FEDERAL COMMUNICATIONS COMMISSION
445 TWELFTH STREET SW
WASHINGTON DC 20554

Re: WLUZ (FM), Levittown, PR
La Gigante Siembra
Facility Identification Number: 11520
Special Temporary Authority
BSTA-20130904ACH
Construction permit application
BPED-20130903AAZ

40 dBu interfering contour
from BNED-20071019 AZH

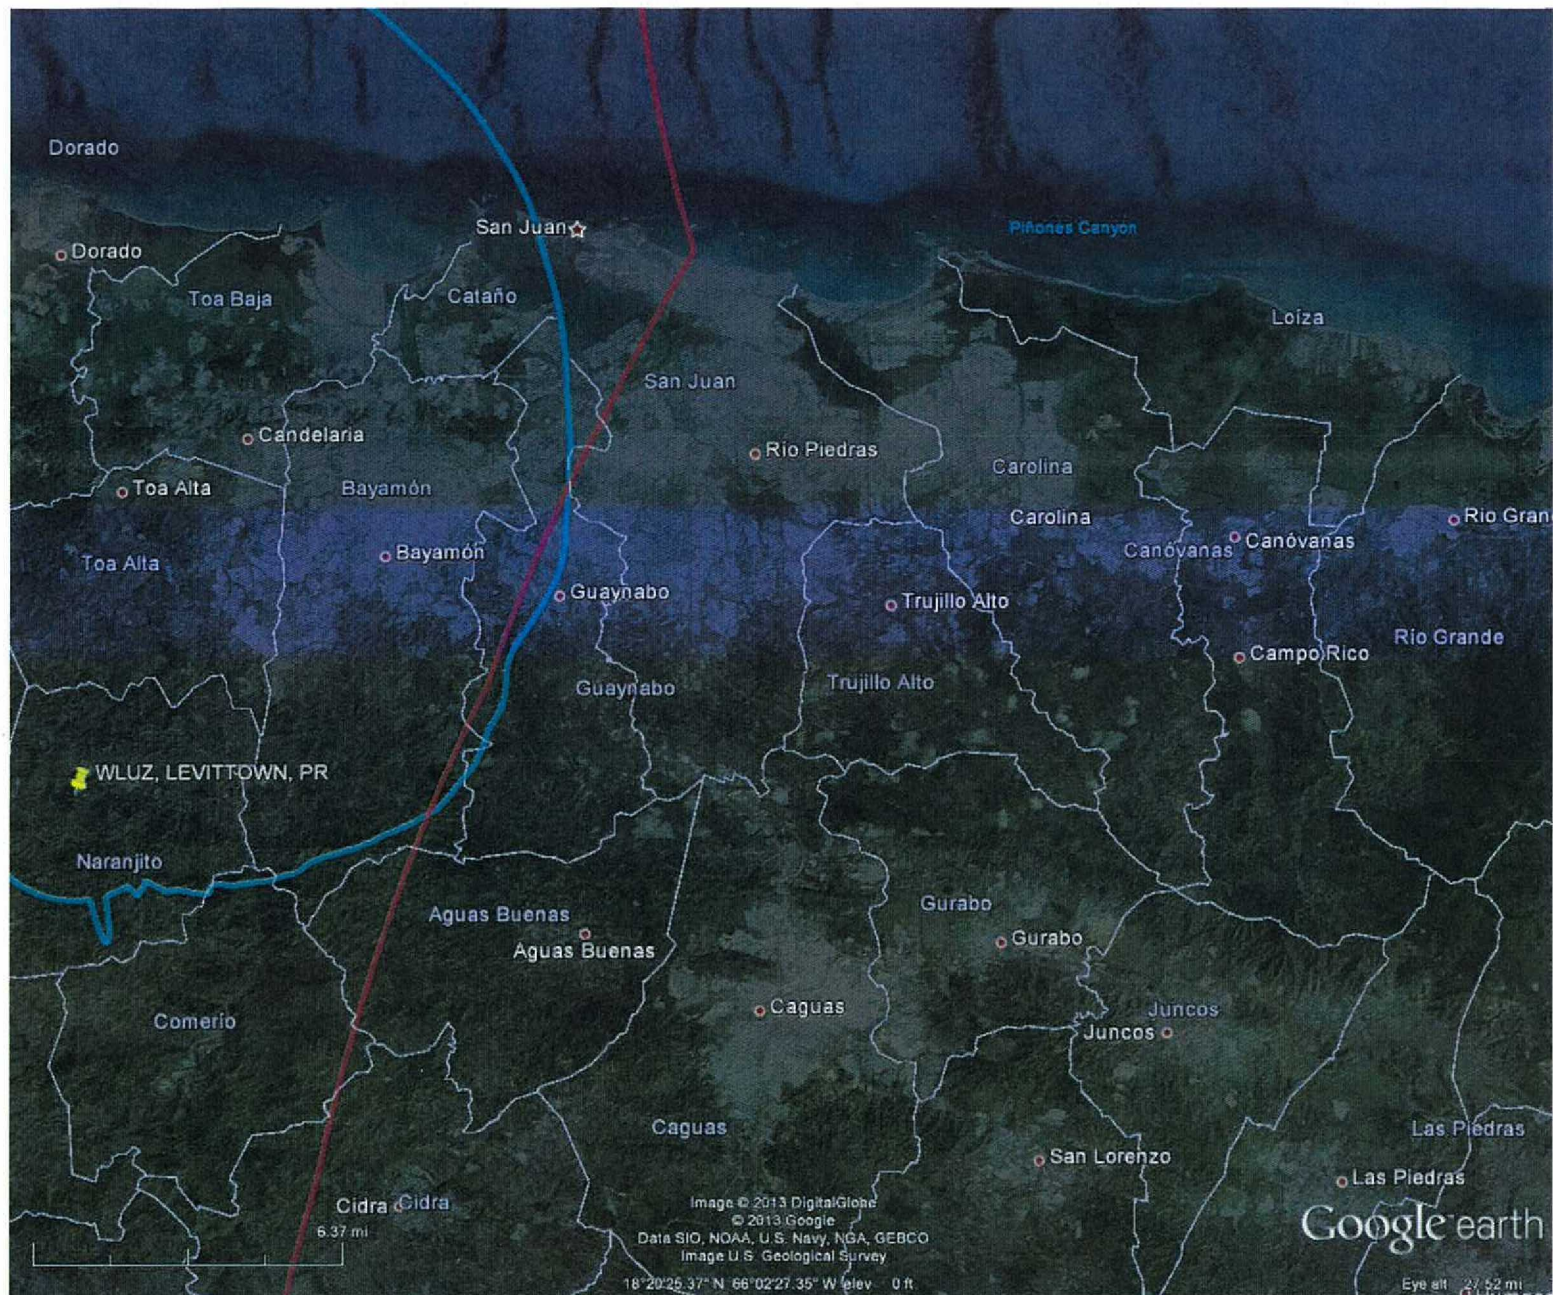
The construction permit application. As a construction permit application, the proposal also suffers from fatal deficiencies. We find that the applicant used the wrong protected and service contour values in conducting its analysis. Under Section 73.509, the protected service contour for noncommercial educational stations in the reserved portion of the FM band (Channels 201-220) is the 60 dBu F(50,50) contour, while the F(50,10) interfering contours are the 40 dBu (cochannel), 54 dBu (first-adjacent channel), and the 100 dBu (second and third adjacent channels). Using the correct contours, we find that prohibited contour overlap will exist between the proposed 60 dBu service contour for WLUZ and the 40 dBu interfering contour of the pending application for a new station at Viques, application file no. BNPED-20071019AZH (see attachment).³ Therefore the proposal is unacceptable for filing.

³ It appears that the applicant relied upon the alternate contours for Puerto Rico and the Virgin Islands in Section 73.215(a)(4), however, those contours are only applicable to FM commercial stations, and those relatively few FM noncommercial educational stations on Channels 218, 219, and 220 that are protecting commercial FM stations. All noncommercial educational stations on Channels 201 to 220 remain governed by the provisions of Section 73.509, NOT Section 73.215.

Given the circumstances, we are willing to expedite consideration of a new minor change application that corrects the listed deficiencies.
